Sundry Notices and Reports on Wells

Stromberg #7
Unit C Sect 33-T23N-R3W
Sandoval County, New Mexico

Re: Permanent Abandonment

Well: 7 Stromberg

Wellbore Schematic

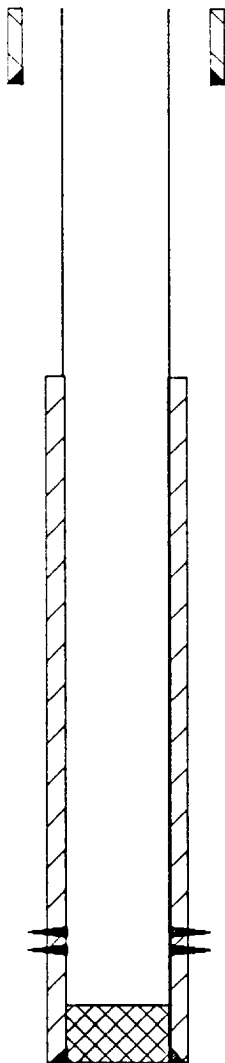
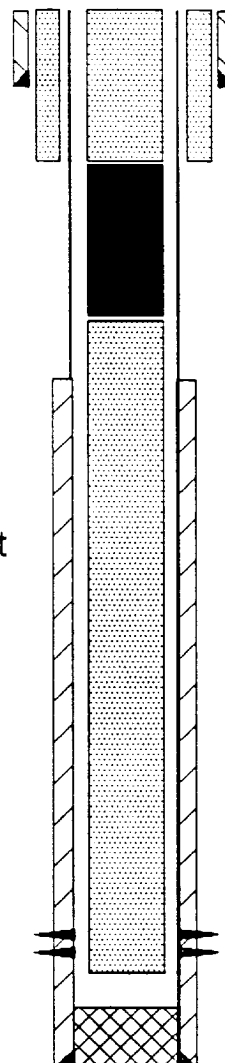
*Add a plug from 1300-1200 inside & outside production casing
(Fresh water zone)*
